HISTORIC AND DESIGN REVIEW COMMISSION

October 20, 2021

HDRC CASE NO: 2021-503
ADDRESS: 183 THORAIN BLVD
LEGAL DESCRIPTION: NCB 9007 BLK 13 LOT S 163.3 FT OF 82 & 83
ZONING: R-4, H
CITY COUNCIL DIST.: 1
DISTRICT: Olmos Park Terrace Historic District
APPLICANT: JUAN SCOTT/DILLARD ARCHITECT GROUP
OWNER: CELINE THOMASSON
TYPE OF WORK: Construction of a new 1-story rear accessory structure, window replacement, siding replacement
APPLICATION RECEIVED: September 23, 2021
60-DAY REVIEW: Not applicable due to City Council Emergency Orders
CASE MANAGER: Rachel Rettaliata
REQUEST:

The applicant is requesting a Certificate of Appropriateness for approval to:

SITE PLAN

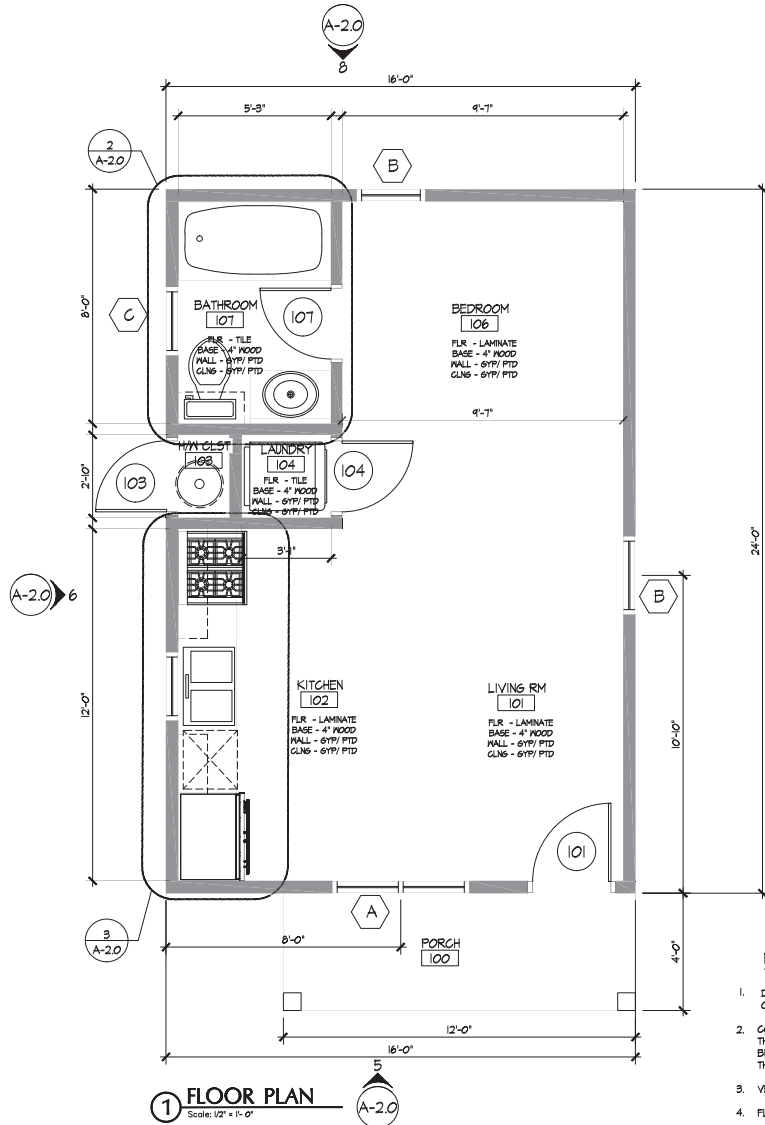
- g. **NEW CONSTRUCTION: SETBACK & ORIENTATION** – The applicant has proposed to construct a new 1-story, 448-square-foot rear accessory structure. According to the Guidelines for New Construction, garages and outbuildings should follow the historic setback pattern of similar structures along the streetscape or district. Historic garages and outbuildings are most typically located at the rear of the lot, behind the principal building. In some instances, historic setbacks are not consistent with UDC requirements, and a variance may be required. Applicants should match the predominant orientation of accessory buildings found along the block. The proposed rear accessory structure will be located at the northeast corner of the property, at the rear, and will be oriented west, facing Howard Street, in the same orientation as the existing rear garage. Staff finds the proposal appropriate.

- p. DRIVEWAY INSTALLATION – The applicant has proposed to install a new driveway with a 10-foot-wide curb cut on the west side of the property to provide an entrance to the proposed rear accessory structure from Howard Street. The property currently features a curb cut and driveway on Howard Street with access to the existing garage and rear yard. Guideline 5.B.ii for Site Elements states that applicants should avoid introducing new curb cuts where not historically found. The properties along Howard Street feature wide driveways and several properties feature more than one driveway. Staff finds the proposal is appropriate for the context of the streetscape.

- q. REAR WALKWAY INSTALLATION – The applicant has proposed to install a stone pathway at the rear of the property connecting the existing concrete pad at the garage to the proposed rear accessory structure. The applicant has not provided dimensions for the proposed walkway. Staff finds that the applicant should provide dimensions and final material specifications for the walkway.

Item 4, staff recommends approval of the construction of the rear accessory structure based on items g through o with the following stipulations:

Item 5, staff recommends approval of the proposed curb cut and driveway installation based on finding p with the following stipulation:

- i. That the driveway does not exceed 10 feet in width and is installed with separation from the existing driveway.

Item 6, staff recommends approval of the rear walkway installation based on finding q with the following stipulation:

- i. That the applicant submits dimensions and material specifications for the proposed rear walkway to staff for review and approval prior to the issuance of a Certificate of Appropriateness.

1 ELEV. WEST ELEVATION

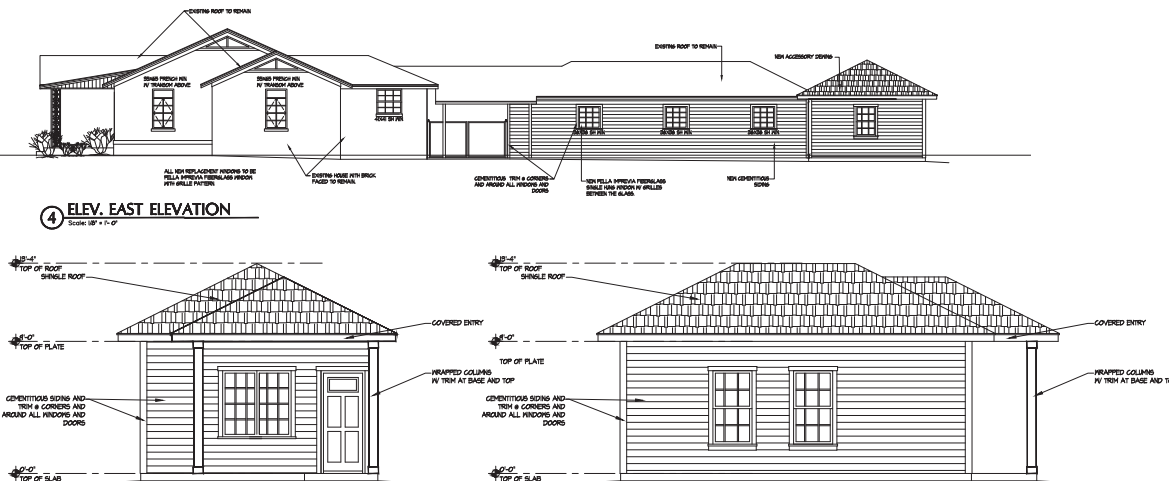
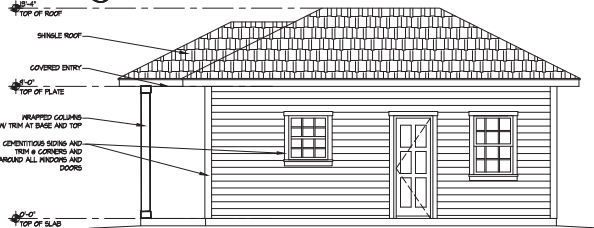
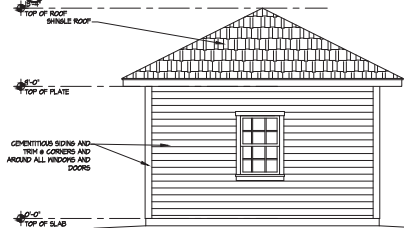
- i. **NEW CONSTRUCTION: ROOF FORM** – The applicant has proposed a hip roof form on the rear accessory structure. According to Guideline 2.B.i for New Construction, new construction should feature roof forms that are consistent with those predominantly found on the block. The primary structure on the property features a side gable roof form and a hip roof on the existing garage. According to the Historic Design Guidelines for New Construction, garage and outbuildings should be designed to be visually subordinate to the principal historic structure in terms of their height, massing, and form and should relate to the period of construction of the principal building on the lot through the use of complementary materials and simplified architectural details. Staff finds the proposal consistent with the Guidelines.

- k. **NEW CONSTRUCTION: MATERIALS AND TEXTURES** – The applicant has proposed to clad the proposed rear accessory structure in cementitious siding, to match the proposed cladding replacement on the existing garage, and a composition shingle roof to match the roofing material of the primary structure. Guideline 3.A.i for New Construction stipulates that new construction should use materials that complement the type, color, and texture of materials traditionally found in the district. Materials should not be so dissimilar as to distract from the historic interpretation of the district. For example, corrugated metal siding would not be appropriate for a new structure in a district comprised of homes with wood siding. Consider using traditional materials, such as wood siding, in a new way to provide visual interest in new construction while still ensuring compatibility. The proposed materials will complement the materials of the primary structure. The applicant has proposed to install wrapped columns for the front porch of the rear accessory structure. Staff finds that the proposal is generally appropriate.

- l. **NEW CONSTRUCTION: WINDOW AND DOOR MATERIALS** – The applicant has proposed to install one-over-one Pella Impervia Fiberglass windows with faux divided lites on the rear accessory structure. Wood or aluminum-clad wood windows and doors are recommended. The windows should feature an inset of two (2) inches within facades and should feature profiles that are found historically within the immediate vicinity. An alternative window material may be proposed, provided that the window features meeting rails that are no taller than 1.25” and stiles no wider than 2.25”. White manufacturer’s color is not allowed, and color selection must be presented to staff. There should be a minimum of two inches in depth between the front face of the window trim and the front face of the top window sash. This must be accomplished by recessing the window sufficiently within the opening or with the installation of additional window trim to add thickness. Window trim must feature traditional dimensions and an architecturally appropriate sill detail. Window track components must be painted to match the window trim or be concealed by a wood window screen set within the opening. The applicant has not submitted material specifications for the pedestrian doors. Staff finds that the applicant should install wood or aluminum-clad wood windows and wood or aluminum-clad wood doors.

- m. **NEW CONSTRUCTION: RELATIONSHIP OF SOLIDS TO VOIDS** – Guideline 2.C.i for New Construction stipulates that new construction should incorporate window and door openings with a similar proportion of wall to window space as typical with nearby historic facades. Windows, doors, porches, entryways, dormers, bays, and pediments shall be considered similar if they are no larger than 25% in size and vary no more than 10% in height to width ratio from adjacent historic facades. Guideline 5.A.iv for New Construction states that window and door openings should be designed to be similar to those found on historic garages or outbuildings in the district or on the principle historic structure in terms of their spacing and proportions. The applicant has submitted elevation drawings of the rear accessory structure that feature traditionally sized pedestrian doors and windows with traditional window proportions. Staff finds the proposal appropriate.

- n. **NEW CONSTRUCTION: ARCHITECTURAL DETAILS** – Guideline 5.A.iii for New Construction states that new garages and outbuildings should relate to the period of construction of the principal building on the lot through the use of complementary materials and simplified architectural details. Staff finds that the applicant has proposed appropriate proportions and a design that is subordinate to the principal building. Staff finds the proposal consistent with the Guidelines.

- ii. That the applicant installs fully wood or aluminum-clad wood windows that meet staff's standard window specifications based on finding g. Wood or aluminum-clad wood windows are recommended and should feature an inset of two (2) inches within facades and should feature profiles that are found historically within the immediate vicinity. Meeting rails must be no taller than 1.25" and stiles no wider than 2.25". White manufacturer's color is not allowed, and color selection must be presented to staff. There should be a minimum of two inches in depth between the front face of the window trim and the front face of the top window sash. This must be accomplished by recessing the window sufficiently within the opening or with the installation of additional window trim to add thickness. Window trim must feature traditional dimensions and architecturally appropriate sill detail. Window track components must be painted to match the window trim or concealed by a wood window screen set within the opening. Windows should feature true divided lites or no divided lites. Faux divided lites are not permitted. Final materials specifications must be submitted to staff for review and approval prior to the issuance of a Certificate of Appropriateness.

- iii. That the applicant submits final material specifications for the proposed doors to staff for review and approval prior to the issuance of a Certificate of Appropriateness.
